Technical Bulletin

Wireless 2-Button PANIC

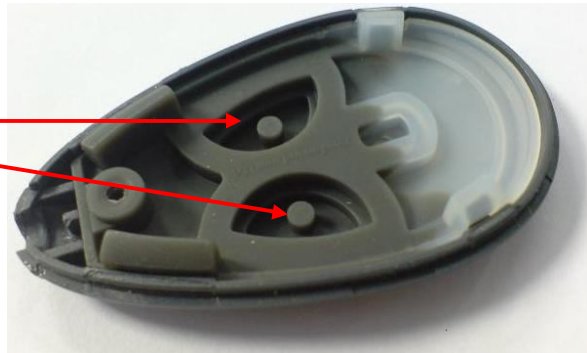
1. Open up the Wireless PA button (one screw on the back of the unit)
2. Prise open the two halves of the unit with a small screwdriver
3. Remove the PCB from within the unit
4. You will see on the rubber membrane. Moulded onto each button place, is a small rubber post (one for each button)

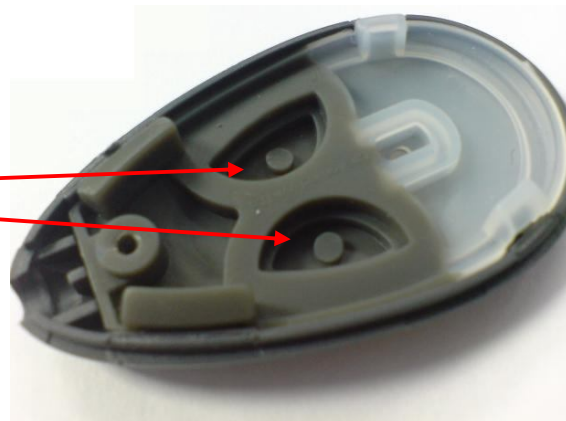
5. Cut approx half the length of the rubber post off.

6. The rubber posts will be shorter
Once cut.

The outcome is that more pressure will now be required (from two fingers) in order for both buttons to be pressed.
